ONE 90 (PREVIOUSLY WATERS TECHNOLOGY PARK )  
PA 18-013 MODIFICATION SUBMITTAL :  
ISSUE DATE: 10-13-20

PA MODIFICATION - INTENT AND DESCRIPTION:  
To review and approve architectural building related design modifications made during plan check for code compliance and constructibility.

PA MODIFICATION COBALT- BLOCKS REVISIONS SUMMARY

PA MODIFICATION - INDIGO ROWS REVISIONS SUMMARY

SECOND LEVEL PLAN TH10

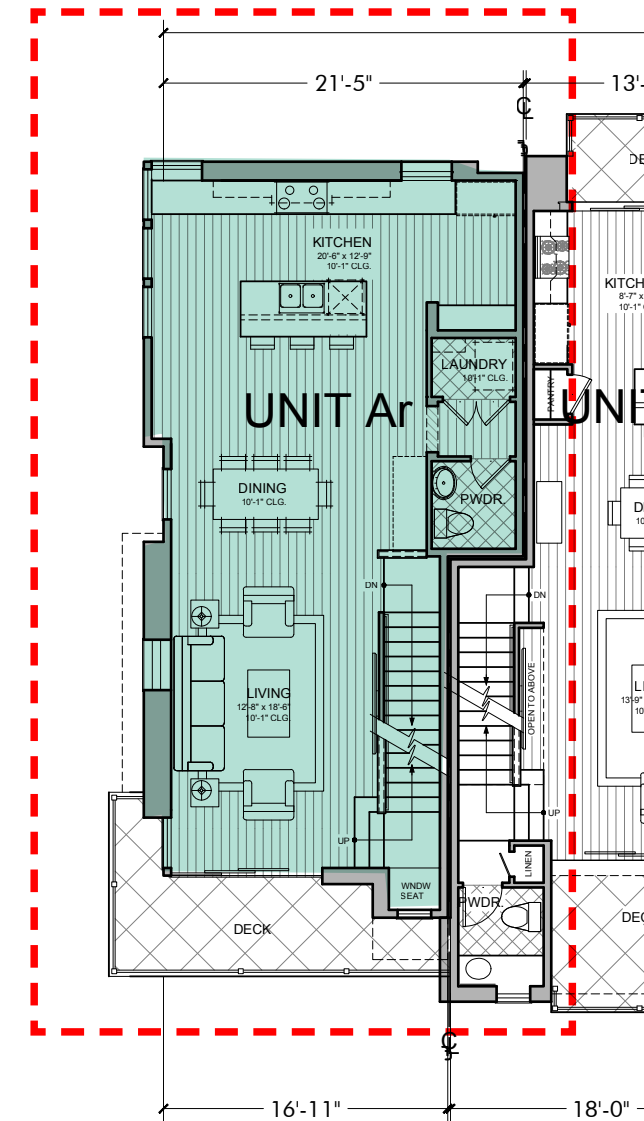
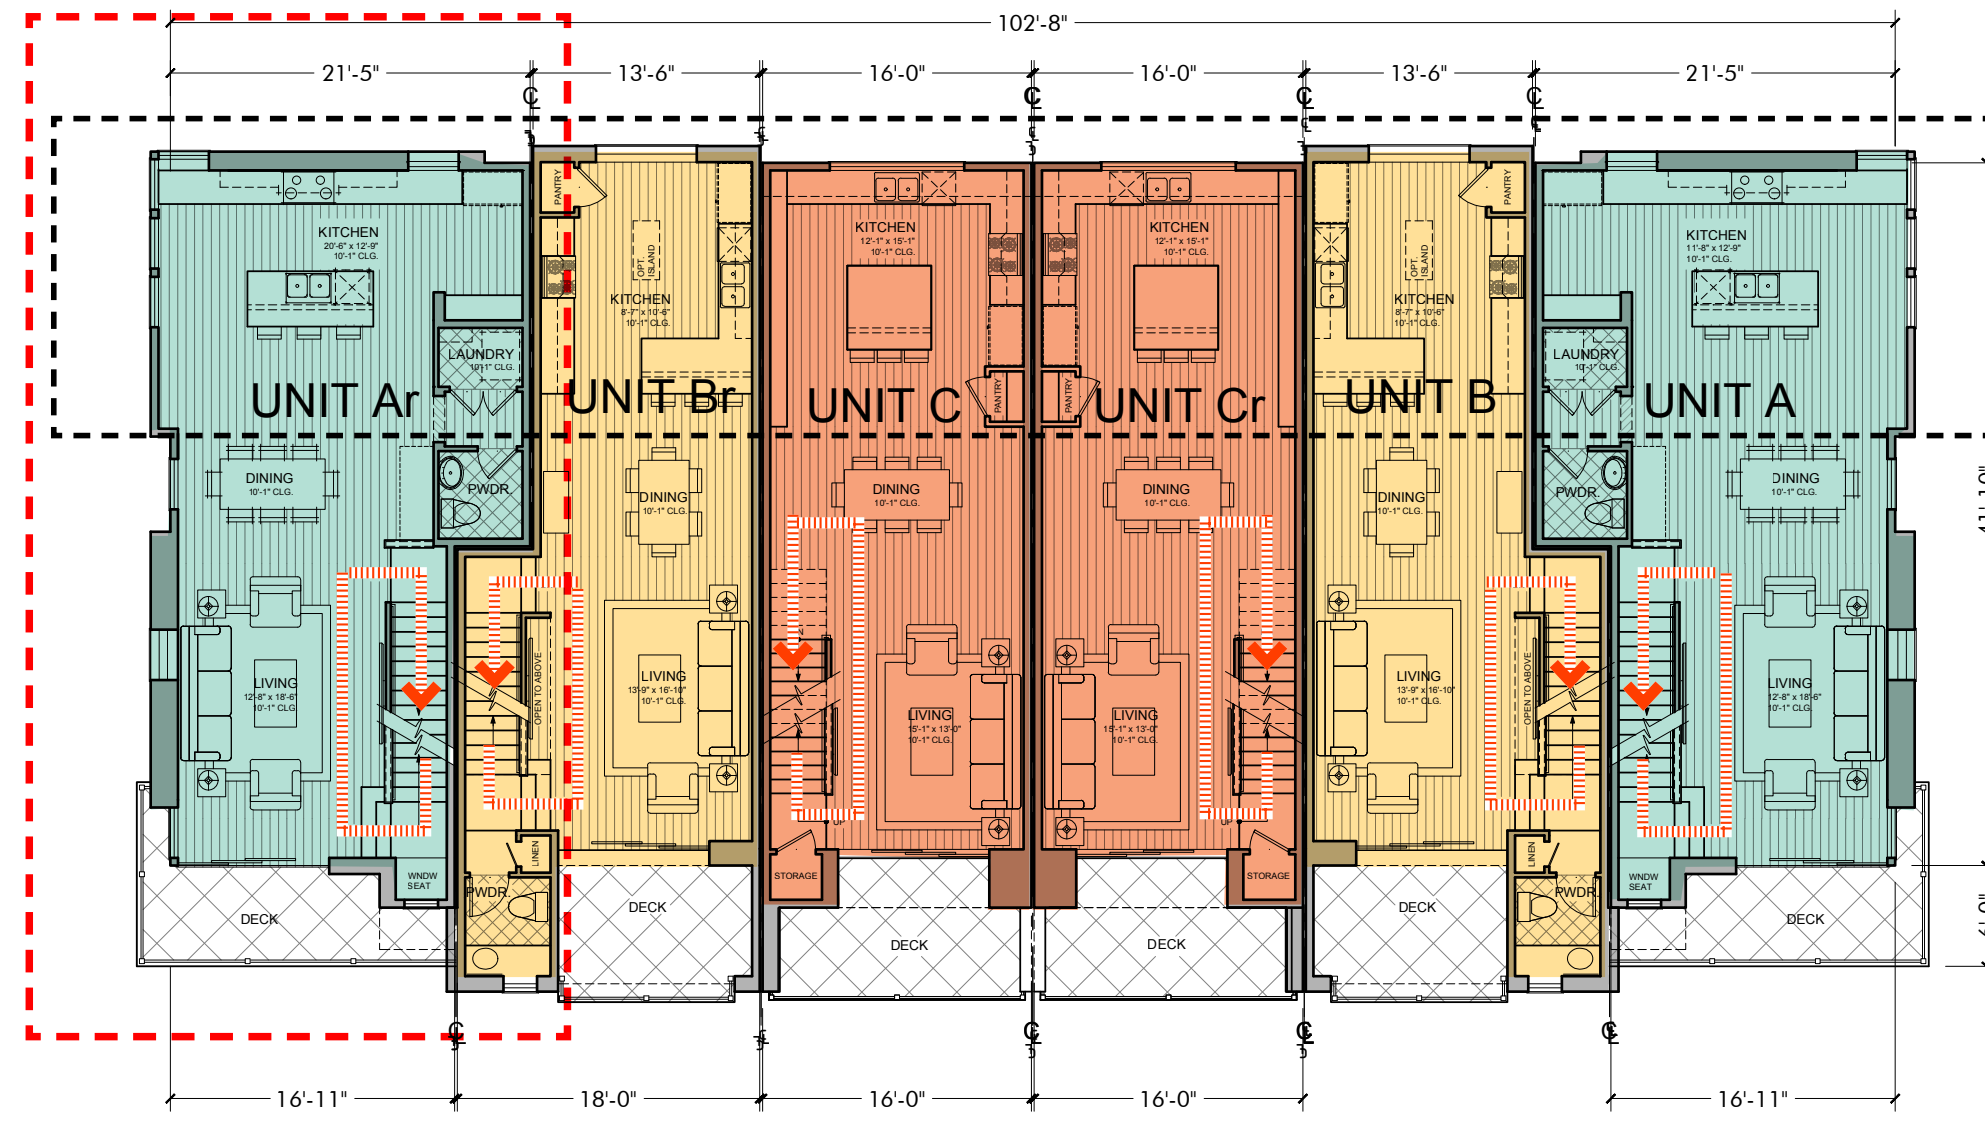
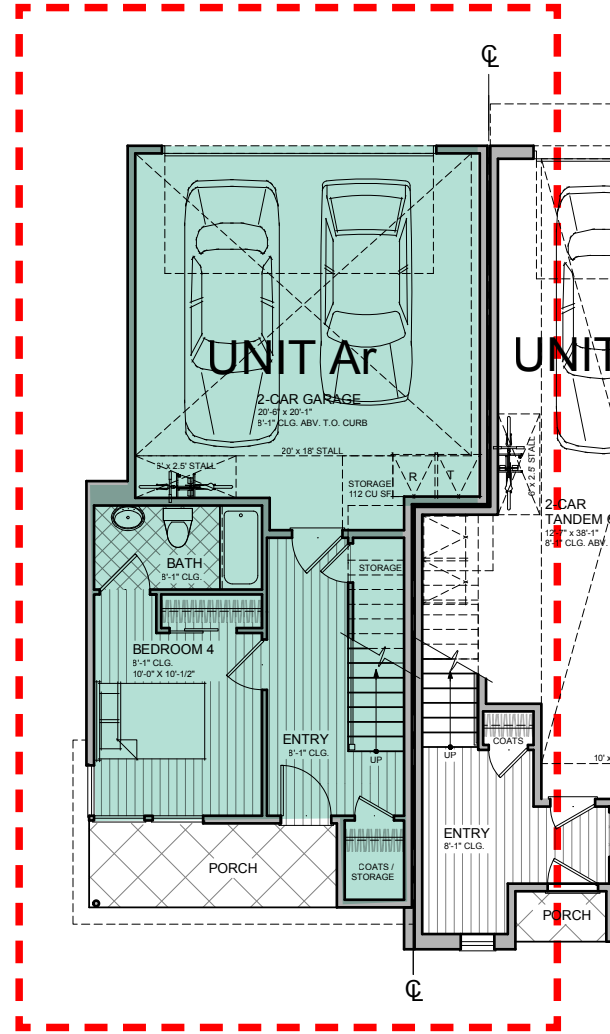
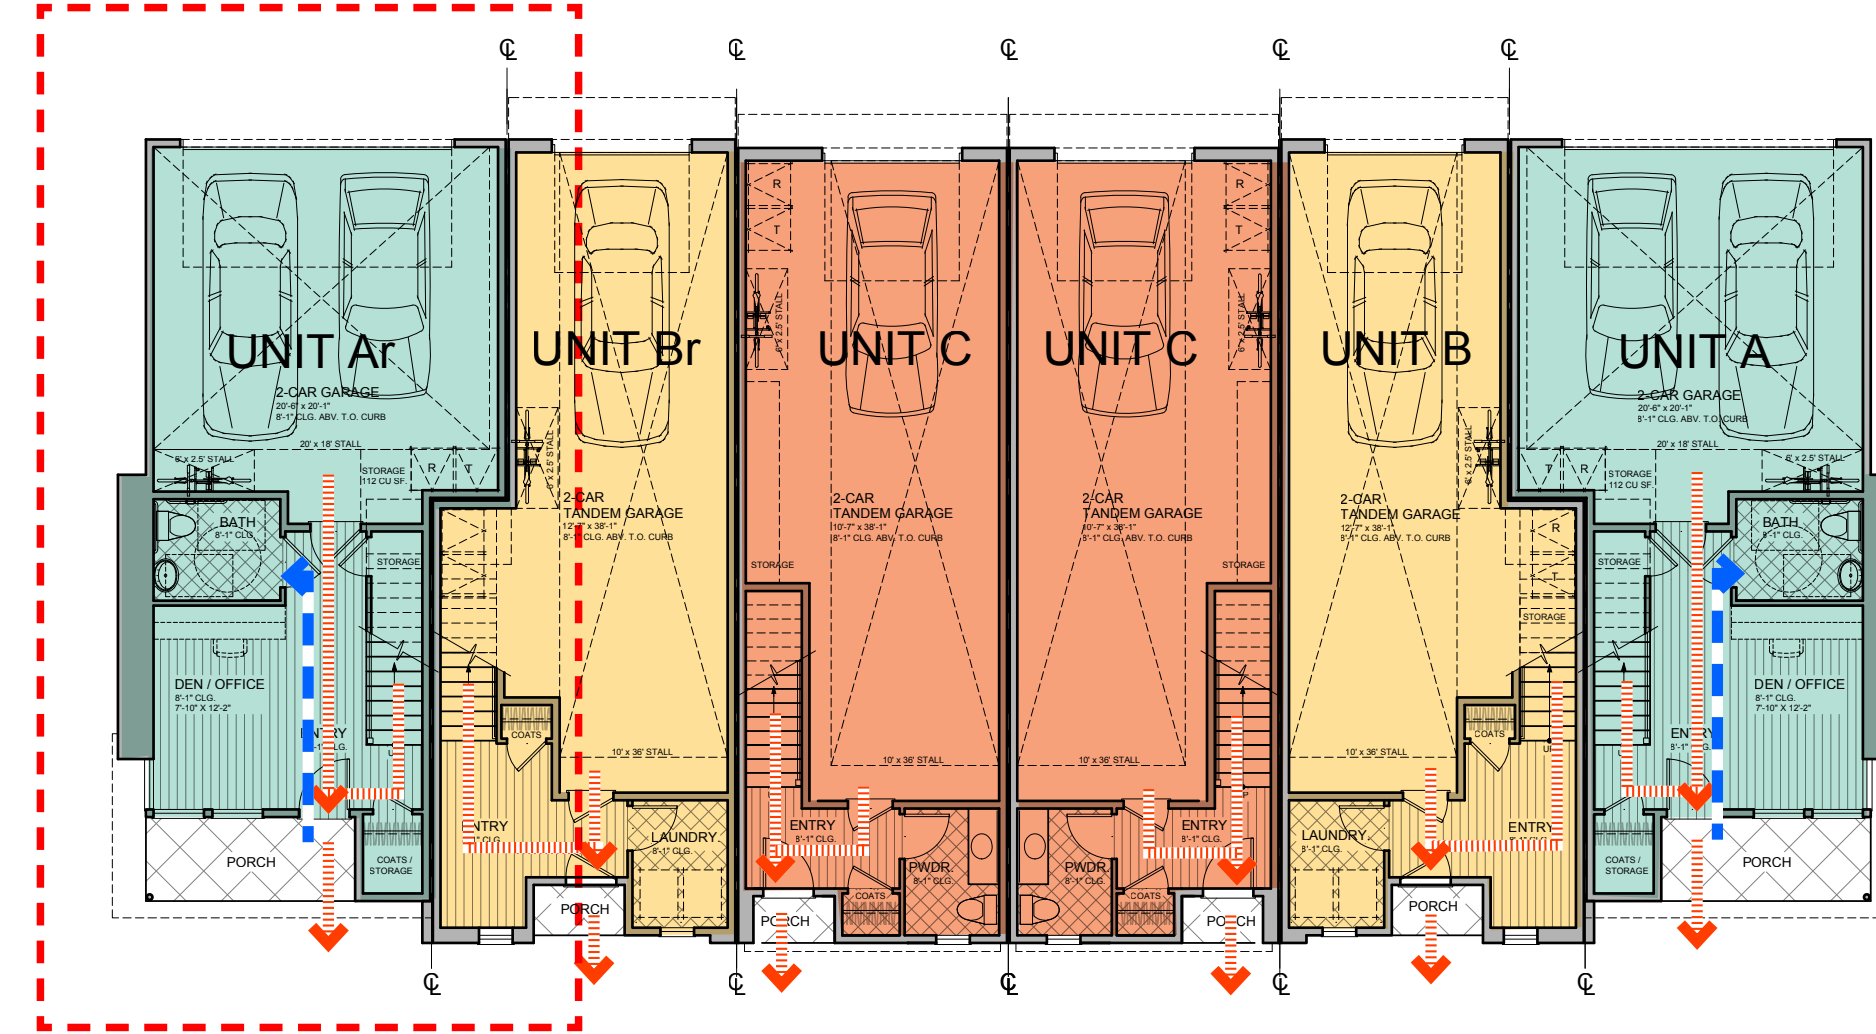
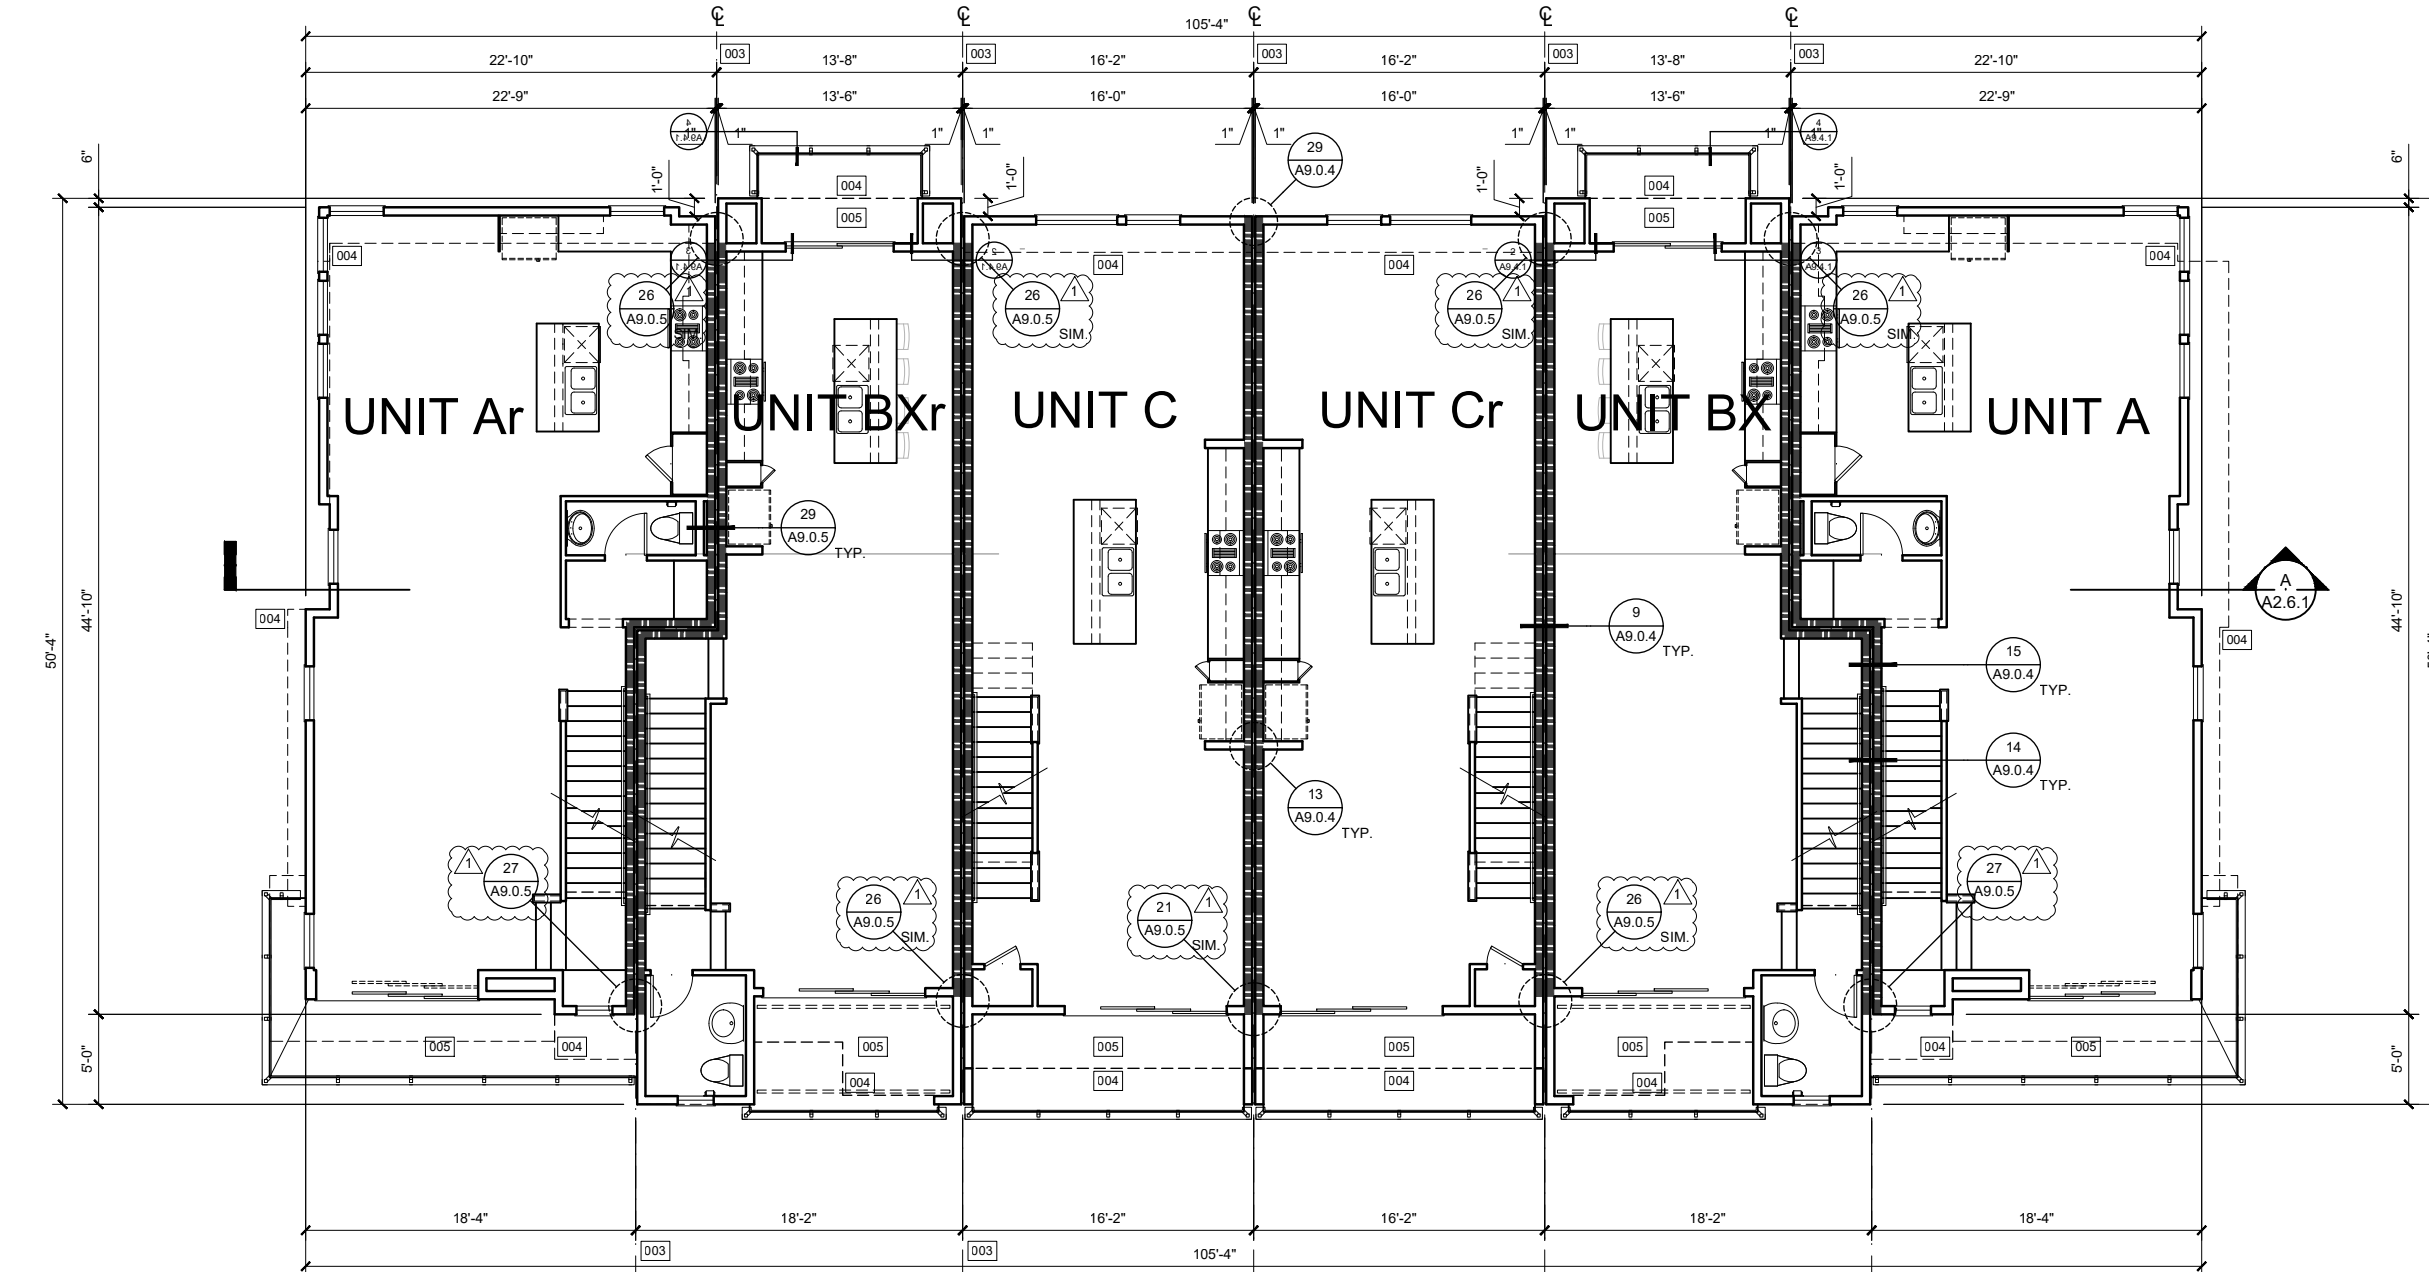
1. Added fire and electrical utility closets  
Townhome 10 is currently renamed as Building A on the revised siteplan.

Please note that PA 18-013 plans did not include dimension and the second floor dimensions were measured to interior of the walls and did not include any dimensions to exterior pop out walls.
